SERVICE BULLETIN

DATE: October 30, 2015 Service Bulletin No. 411D
(Supersedes Service Bulletin No. 411C)
Engineering Aspects are
FAA (DER) Approved

SUBJECT: Adapter Kit for Magneto Isolation Drive

Figure 1
Magneto Drive and Component Parts
IO-360-B4A Engines (Not Installed On Piper PA28-181 (Archer III) Aircraft)
and O-360-A4A, -A4J, and -A3A Engines

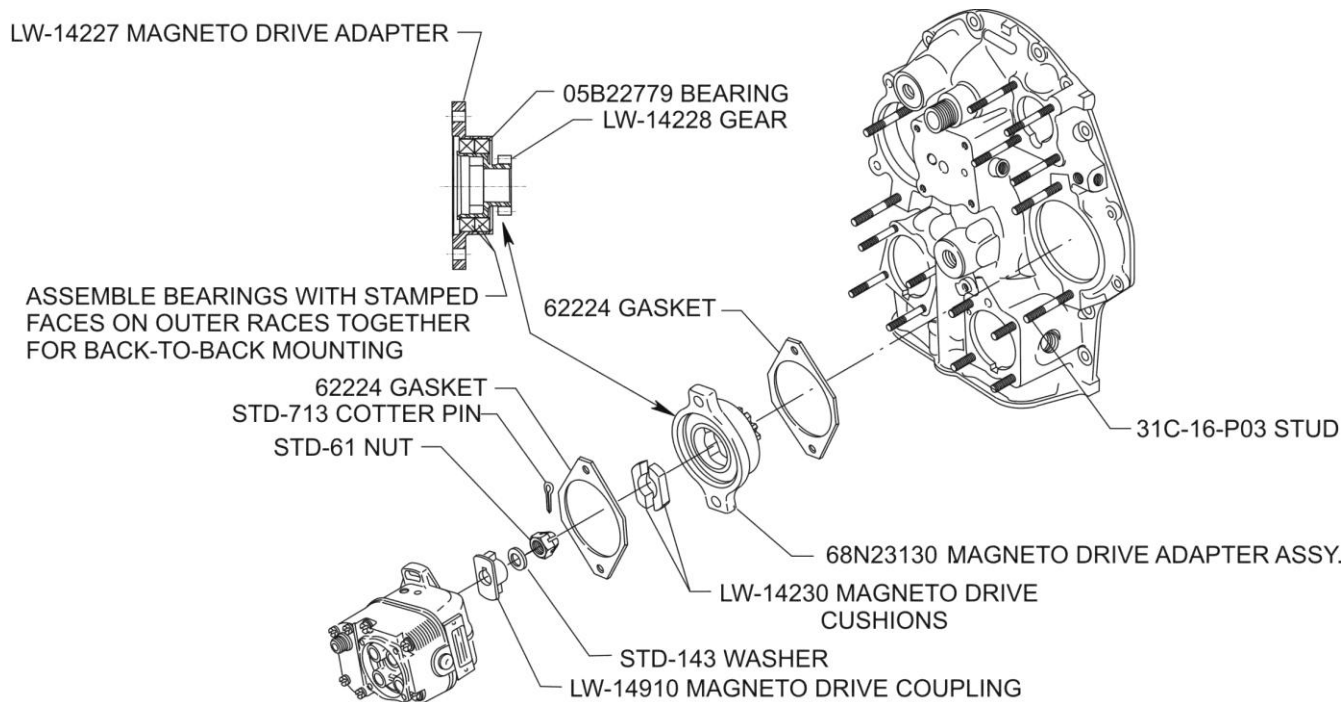
Also, a modification kit is now available for field installation as described in the following procedure. Note that this modification consists of removing the right magneto, replacing the attaching studs in the accessory housing, and replacing the drive components of the magneto as shown in Figure 1.

1. Remove the right magneto and the attaching studs in the accessory housing.
2. Install the two (2) P/N 31C-16-P03 studs in the accessory housing. The correct driven height of these studs is 1.34 to 1.38 in. (34 to 35 mm).

3. Place a new P/N 62224 gasket over the studs on the magneto mounting pad in the accessory housing. Then install P/N 68N23130 magneto drive adapter over the studs.

6. Install the P/N LW-14910 magneto drive coupling on the magneto shaft; then reassemble the washer and nut removed in Step 4. Torque the nut to 20 to 25 ft.-lb. (27 to 34 Nm) and secure the nut with a new P/N STD-713 cotter pin.

7. Install two (2) P/N LW-14230 drive cushions in the P/N 68N23130 magneto drive adapter, then place a P/N 62224 gasket over the studs against the adapter and reassemble the magneto on the engine.
